NUMBER: 18-102-22

This bulletin supersedes Technical Service Bulletin (TSB) 18-012-21 REV. B, date of issue June 26, 2021, which should be removed from your files. All revisions are highlighted with **asterisks**** and include and includes updated notes and inspection section.**

Flash: Powertrain Control Module (PCM) Updates

2020	(DJ)	RAM 2500 Pickup
2020	(D2)	RAM 3500 Pickup

**Fig. 1
CP3.3 Design Pump**

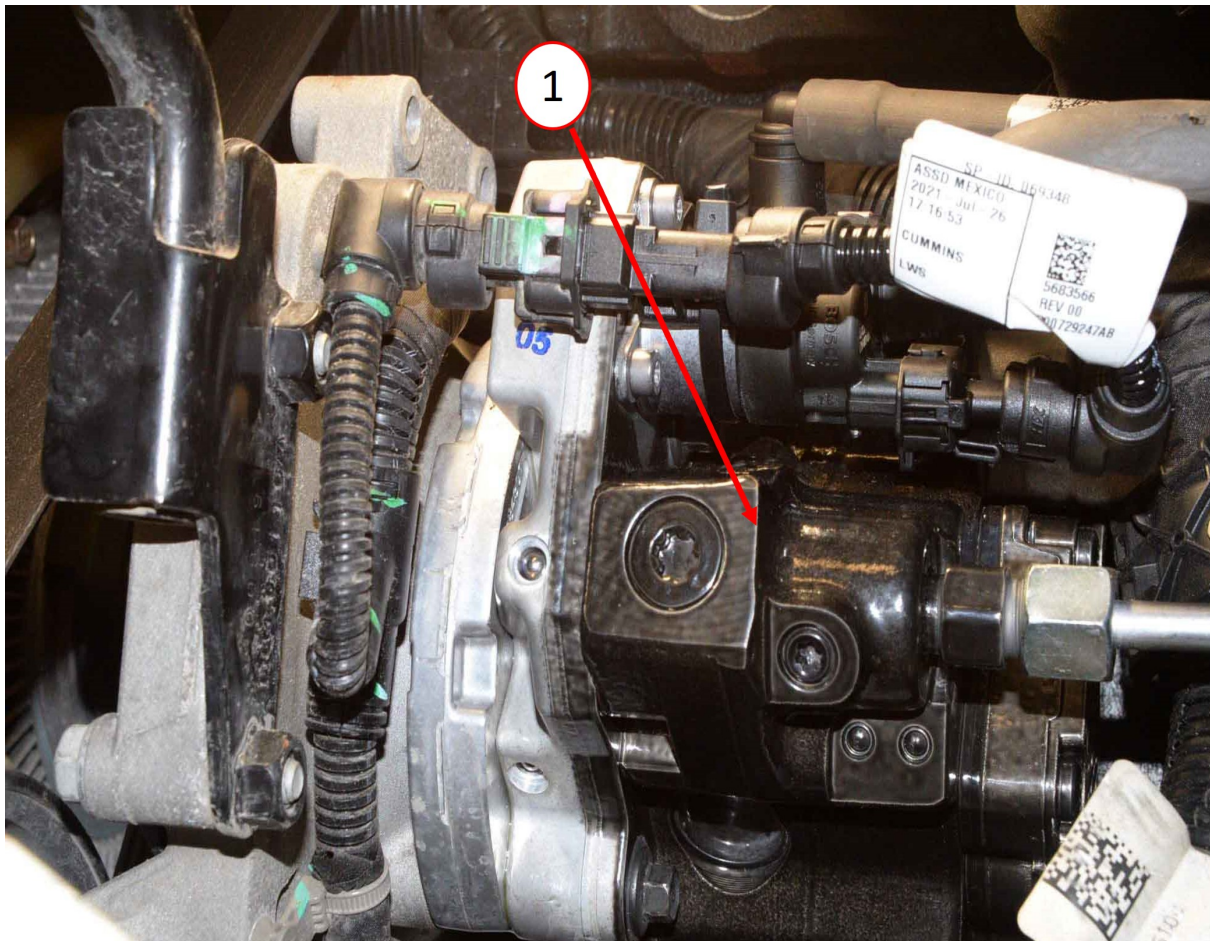
NOTE: **The only calibration available will be for the updated CP3.3 design High-Pressure Fuel Injection Pump (Fig. 1) . Please ensure that recall Y78 has been completed first before proceeding with this update.

1. Inspect the High-Pressure Fuel Injection Pump to see which pump is currently installed on the vehicle (Fig. 1) . Also review the vehicle VIP report to see if campaign Y78 has been performed.

2. Does the VIP report indicate that Y78 has been performed, and is the vehicle equipped with the new design fuel injection pump released under the campaign?
 - YES>>> Proceed to [Step 1](#).
 - NO>>> Perform the Y78 campaign first. Once the campaign is performed, new pump installed and PCM updated, the PCM will have all of the updates listed in this document. This Bulletin does not apply.**
